Re: Objections to Brook Mining Co., LLC Coal Mining Permit Application

On behalf of the members of the Powder River Basin Resource Council (“Resource Council”), our organization hereby submits these objections to the proposed coal mining permit for Brook Mining Co., LLC (“company” or “applicant”) in Sheridan County.

FIGURE 4.1 ILLUSTRATION OF PROPOSED HIGHWALL MINING OF COAL VIA STRIP-MINED TRENCH EXCAVATIONS (SEE P. MP-F2)

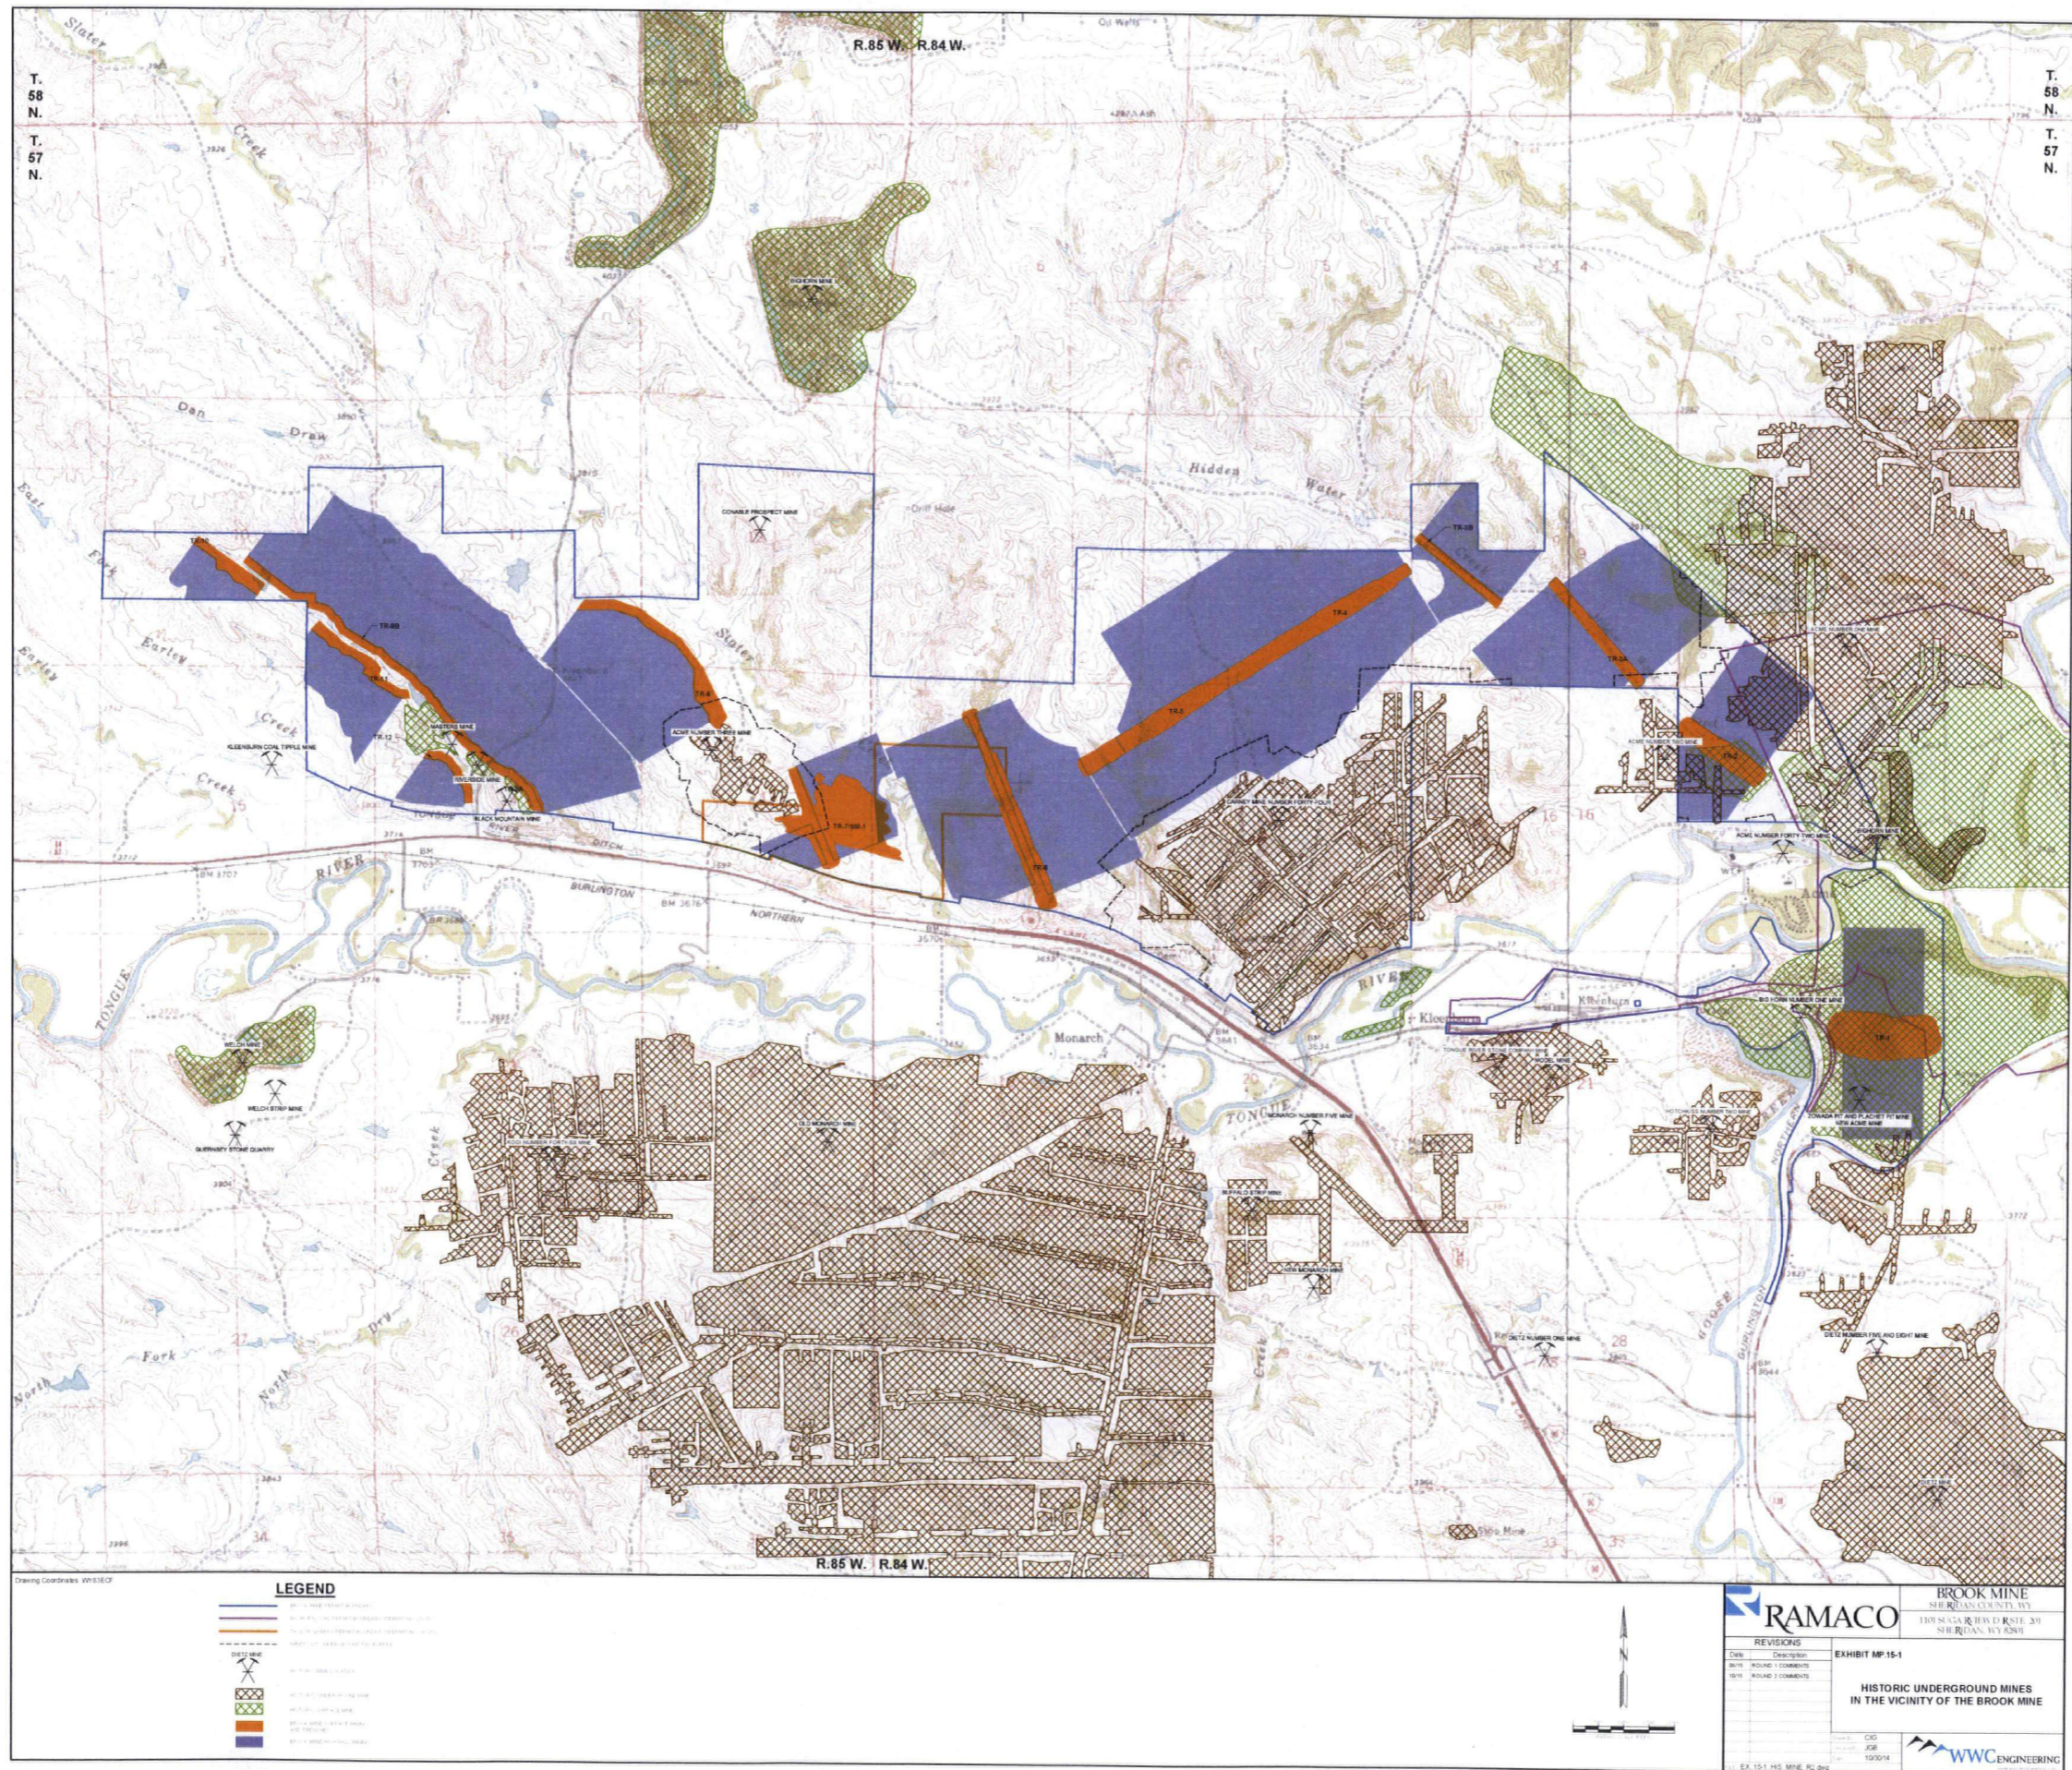
Ramaco plans to mine with the reserve area mainly in two coal seams. They are the Carney and Masters coals. In the western part of the reserve, the Carney coal seam splits into upper and lower beds. Because these mineable beds are covered, Ramaco plans to create highwalls to expose them by excavating mainly slots or areas by strip mining. Once the mineable seam(s) are exposed, they will be extracted utilizing a remote-controlled continuous miner and conveyor system. An illustration of this proposed highwall operation was provided by Ramaco in Figure 4.1.

FIGURE 4.4 PROPOSED HIGHWALL MINING AND PILLAR CONFIGURATION (SEE P. MP-F3)

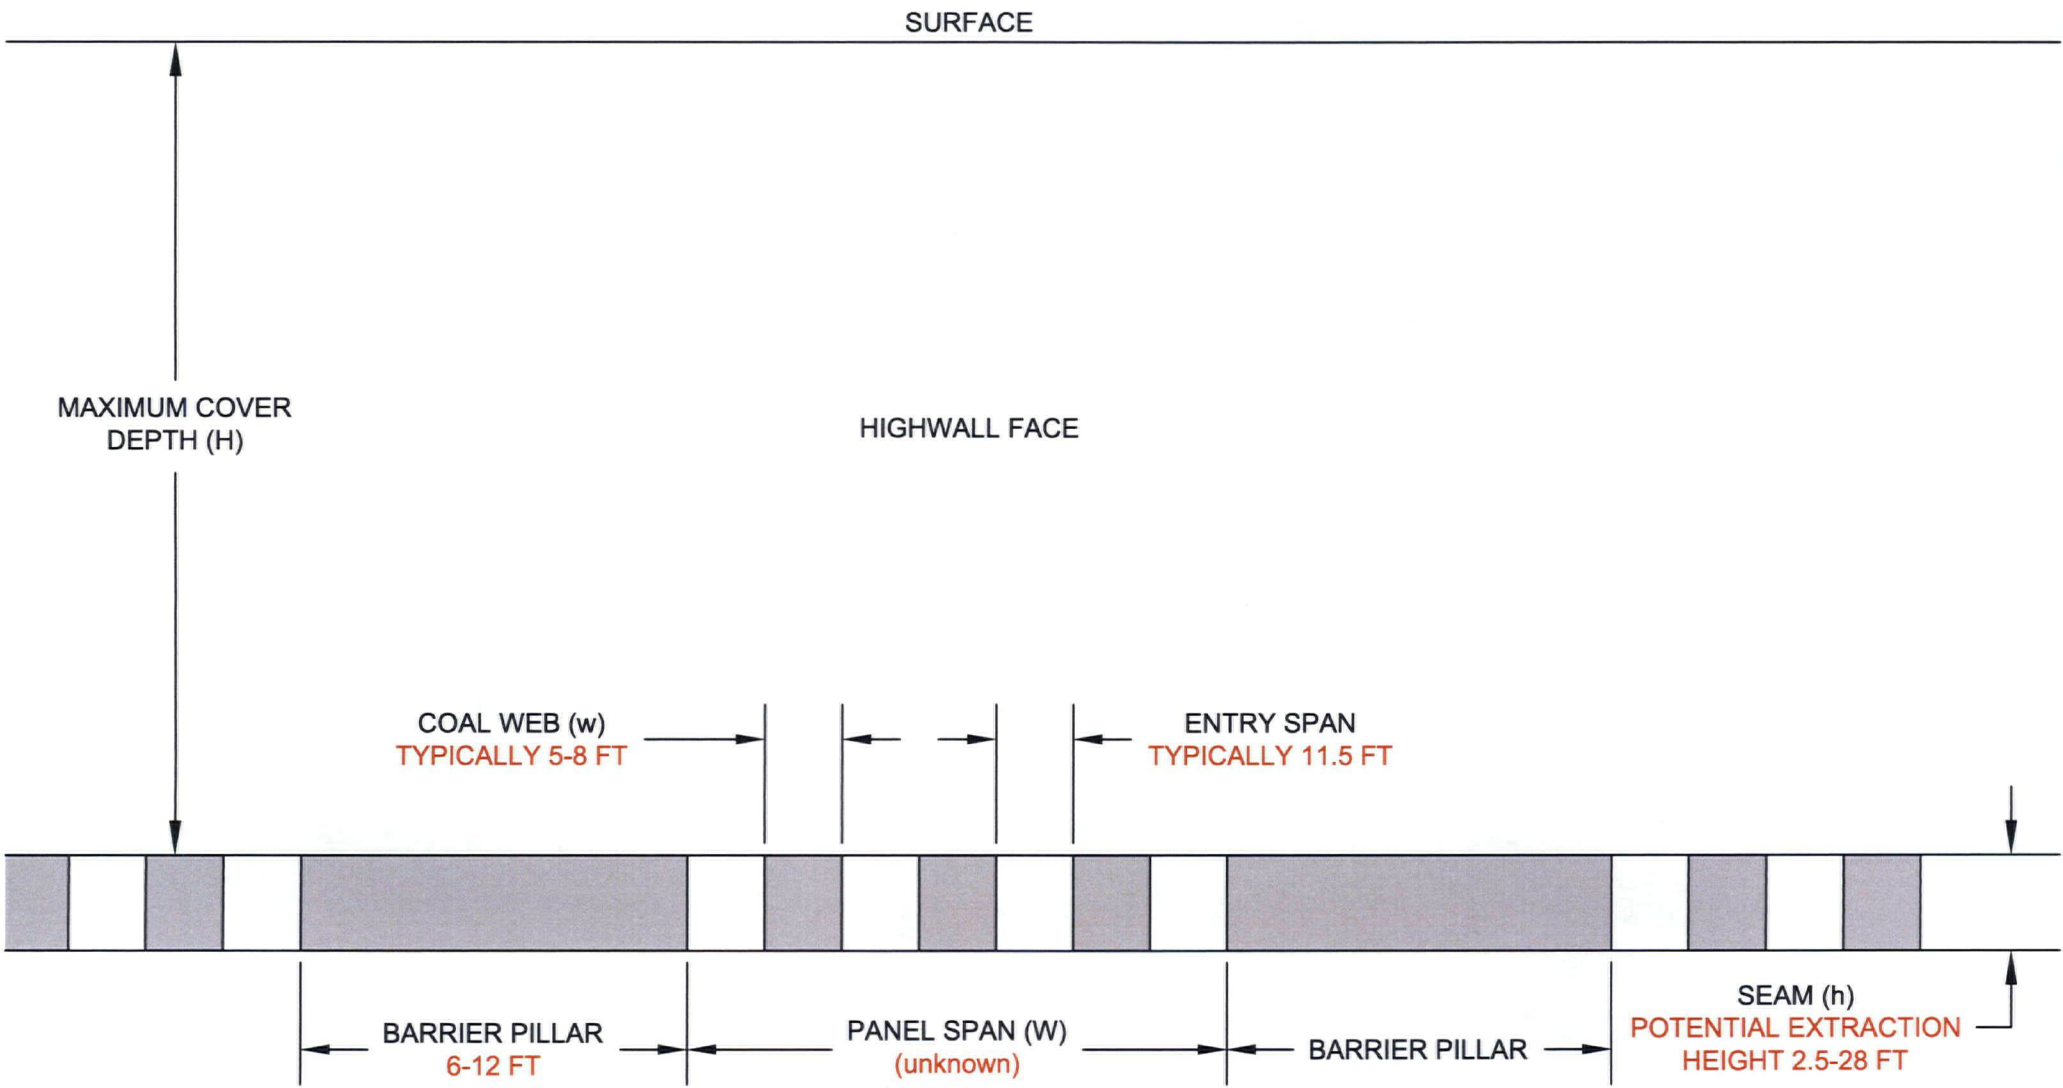
The proposed room and pillar configuration is depicted in Figure 4.4. As can be seen in Figure 4.4, there is no definitive geometry stipulated in the application as much of the identified dimensions are qualified. Using the "typical" web pillar widths and room width, the panel extraction ratio would vary from 59% to 70% in the panels.
